1. **Case #H-00-129.** 320 Camino Delora. Downtown and Eastside Historic District. Non-contributing. Steve Marlens proposes the rehabilitation of a non-contributing house and the construction of a yardwall and gates. (Postponed at the 9/12/2000 HDRB meeting).

Project description : RHDBTN HSE, GRG, YRD WL CONSTRUCTION
Project number : 00-10100141
Case number : H-00-129
Project type : HISTORIC DESIGN REVIEW BOARD

DATE: October 10th, 2000

CASE # H-00-129

NORTH (DETAIL)

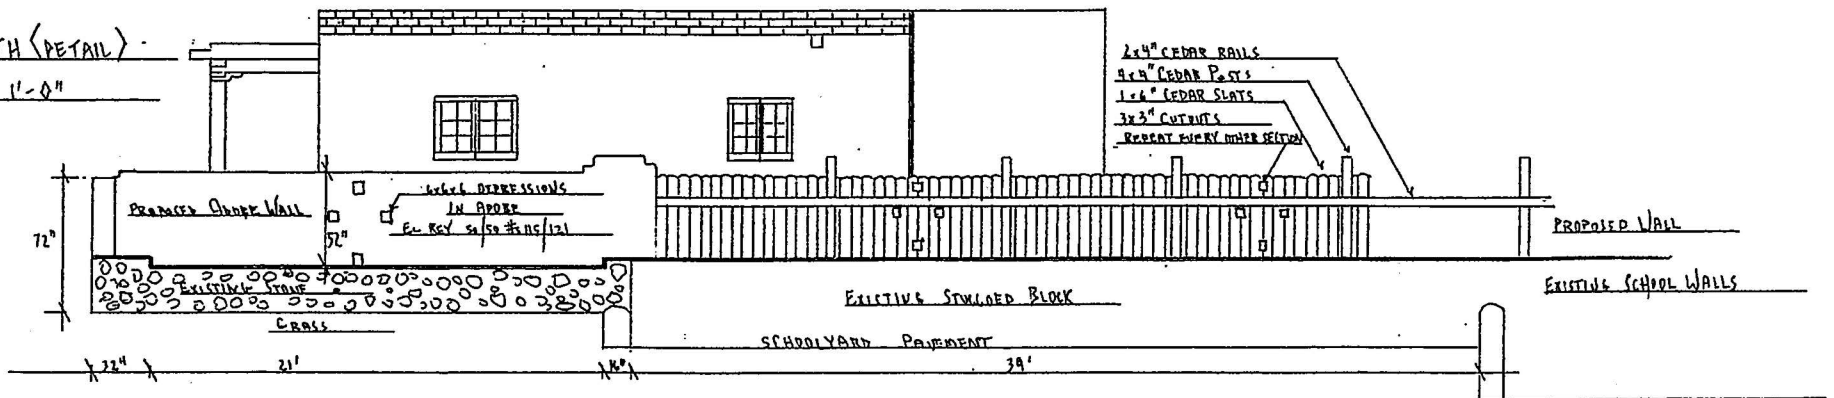
Mr. Padilla asked Mr. Hewat if on the proposed north elevation, the wall was 72" high. Mr. Hewat agreed, saying it was measured from the highest point of the grade to the top of the wall there by Cristo Rey School. He said the applicant needed the height there by the school. The applicant further explained the height of the wall to the satisfaction of the Board.

EAST (PRIMARY) ELEV. - PROPOSED

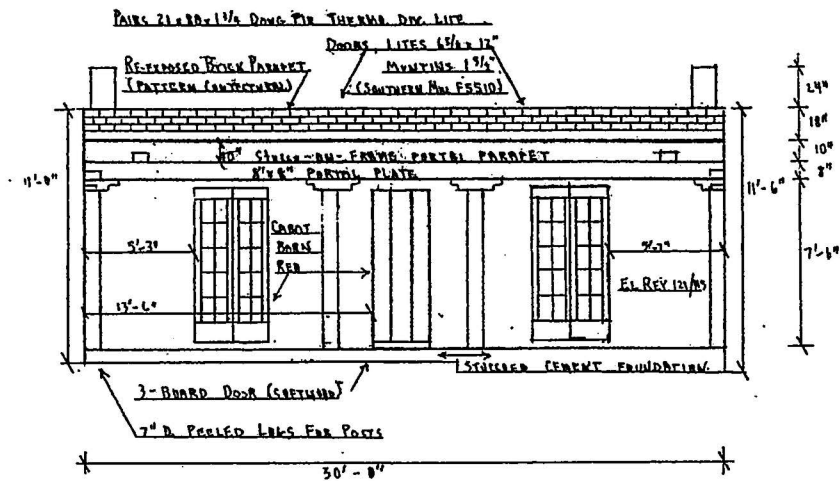
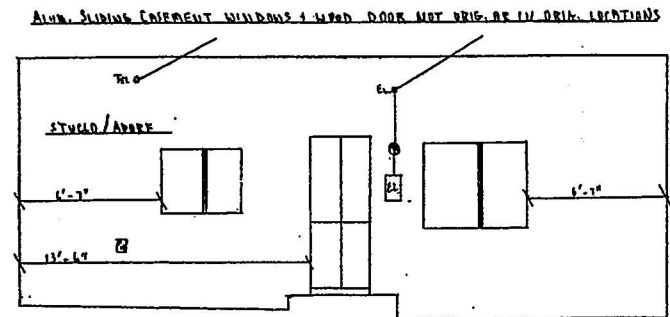
Mr. Purvis agreed that it was much clearer. He asked what the applicant would do if brick was not found on the parapet beneath the stucco. Mr. Marlens said he would not put brick on it if none was found beneath but added that he could see the brick from the roof.

Mr. Purvis asked the color of the beams. Mr. Marlens said there would only be two colors for the entire project: the color of the stucco and the barn red color for everything else. He asked if the Board would be willing to give him discretion in either painting the beams and posts red or not painting them at all, he would appreciate it. He said if they couldn't, he would paint them red.

Mr. Purvis said his recommendation was to approve it both ways, saying his preference was not to paint the beams and posts. Mr. Padilla agreed, saying he would recommend that they not be painted and if the applicant would like to paint them, that it come back to staff for review. Mr. Marlens agreed.

The motion to approve per staff recommendations with the condition that the beams and posts not be painted passed by unanimous voice vote.
